**ITEM 4. DEVELOPMENT APPLICATION: HAROLD PARK - 10 MAXWELL ROAD - 72 AND 74 ROSS STREET - 1A AND 1B THE CRESCENT - FOREST LODGE****FILE NO:** D/2011/1298**SUMMARY****Date of Submission:** 17 August 2011. Amended plans and documentation submitted up until 28 June 2012.**Applicant:** Mirvac**Architect:** Hassell, Mirvac Design, ASPECT**Developer:** Mirvac**Site:** Harold Park (10 Maxwell Rd, 72 and 74 Ross St, 1A and 1B The Crescent, Forest Lodge).**Summary:** Stage 1 Development Application for the redevelopment of Harold Park.

**Summary Recommendation:** The development application is recommended for approval, subject to conditions.**Development Controls:**

**Figure 63 – Turning circle at end of road MC04.**

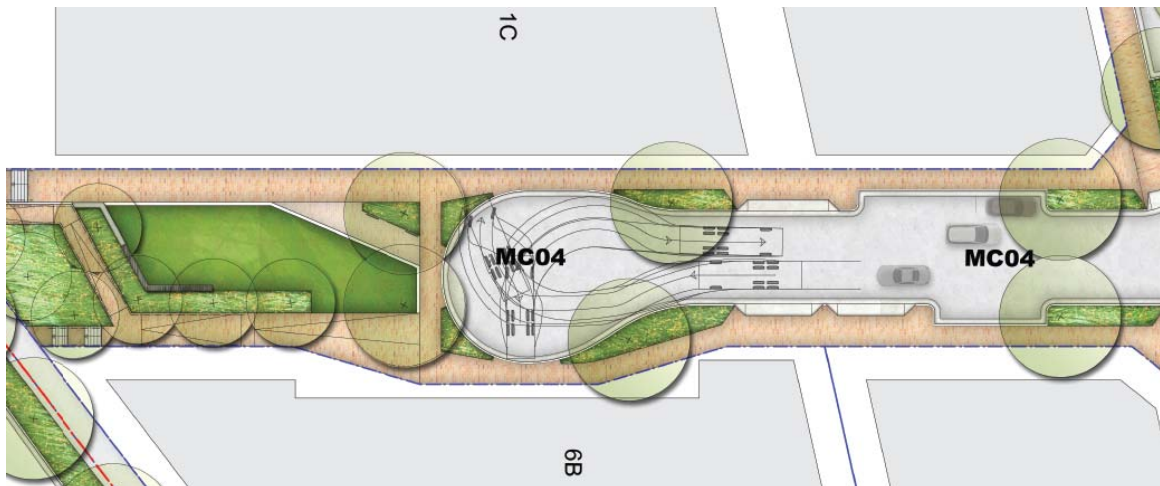
214. To ensure Council's waste vehicles can perform three-point-turns, turning areas have been provided at the ends of roads MC03 and MC04. The proposed design is shown below at **Figure 63**. It is noted that the balance of the drawings do not reflect the rounded turning circle design as this is an amended design provided to address concerns about streetscape impacts and parking.

215. The same treatment is proposed to MC03 which is supported subject to the turning area being replicating and not mirroring MC04. This will ensure that swept paths are efficient and less of the public domain is impacted reducing streetscape impacts.

Figure 68 – Original proposed levels. The main areas where levels have been reduced are shown clouded.

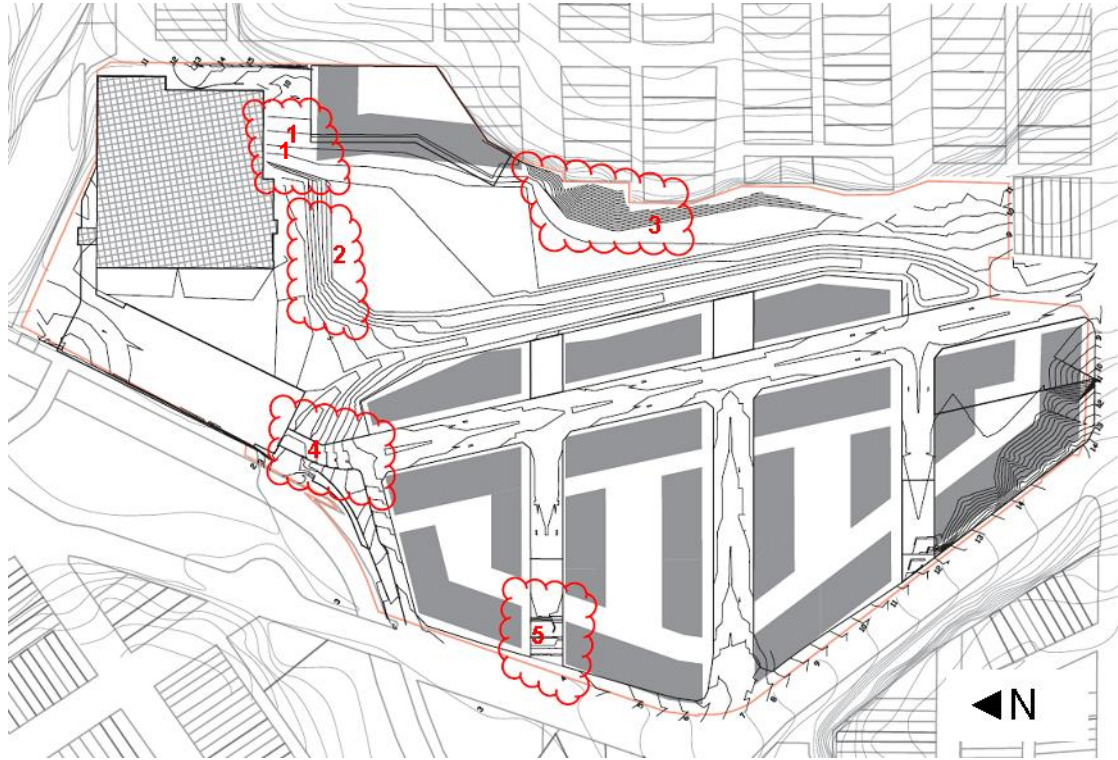
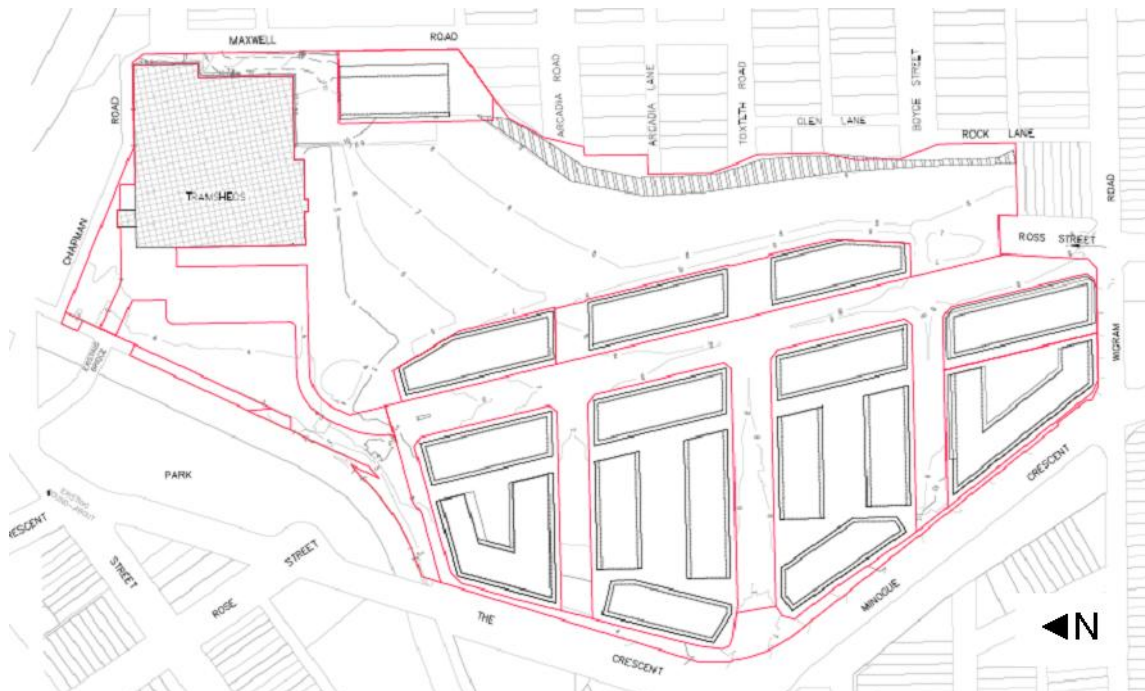
230. Following concerns raised by the City about original proposed site levels, amendments were made to re-grade the site. **Figure 68** below shows the original levels and identifies the locations where changes have been made (main changes summarised in the table below). **Figure 69** shows the amended levels.

**Figure 70 – Original levels which encroached on the Tram Shed's curtilage and disrupted views to and from the Tram Sheds.**

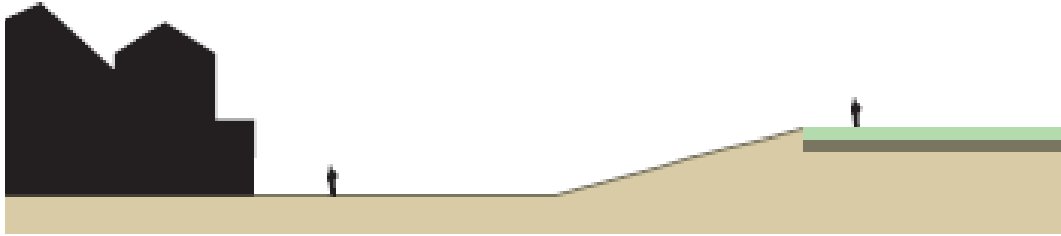
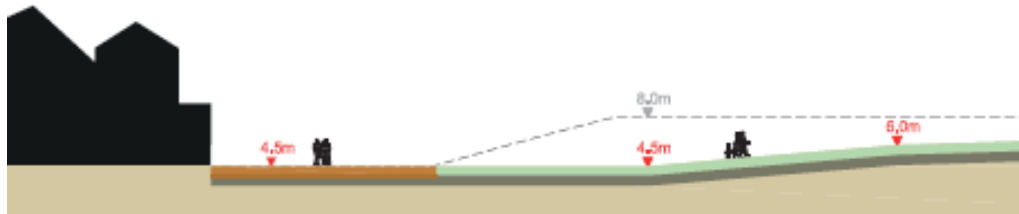
231. Significant improvements have been made to the levels around the Tram Sheds as shown on **Figures 70** and **71** below.
